Amendments to the Drawings:

REMARKS

Claims 59-93 are pending in the present application. Claim 59, 75, and 90 has been amended.

FIGURE 2

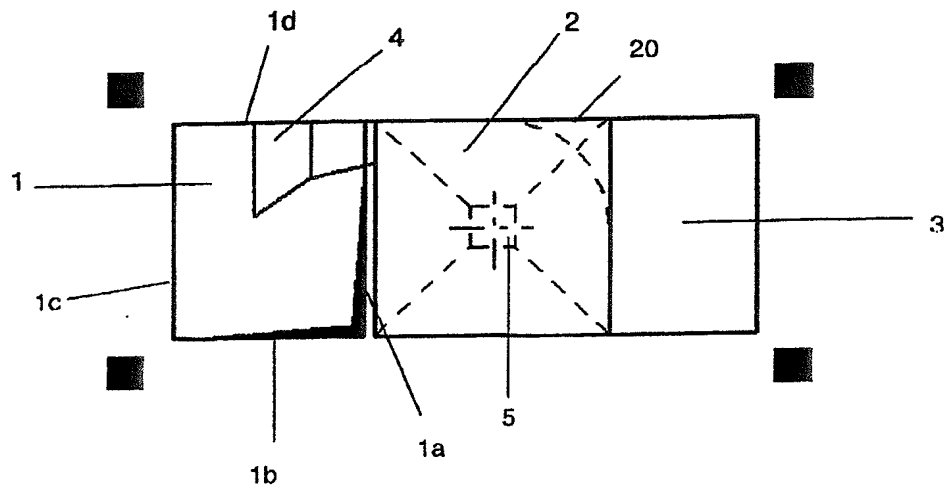
The attached sheet of drawings includes changes to Fig. 2. This sheet, which includes Figs. 1 and 2, replace the original sheet including Figs. 1 and 2. In Fig.2, the embodiment has been amended to include a double wall between the reaction chamber 1 and separator 2.

1. The drawings were objected to under 37 CFR 1.83(a) for failing to show every feature of the invention specified in the claims. Claims 75 and 90 have been amended to clarify the claimed invention. These limitations are provided in the existing drawings. Further, Fig. 2 of the drawings has been amended to include the claimed feature (double wall) of the invention (claim 61). Applicants submit that this objection is now moot.
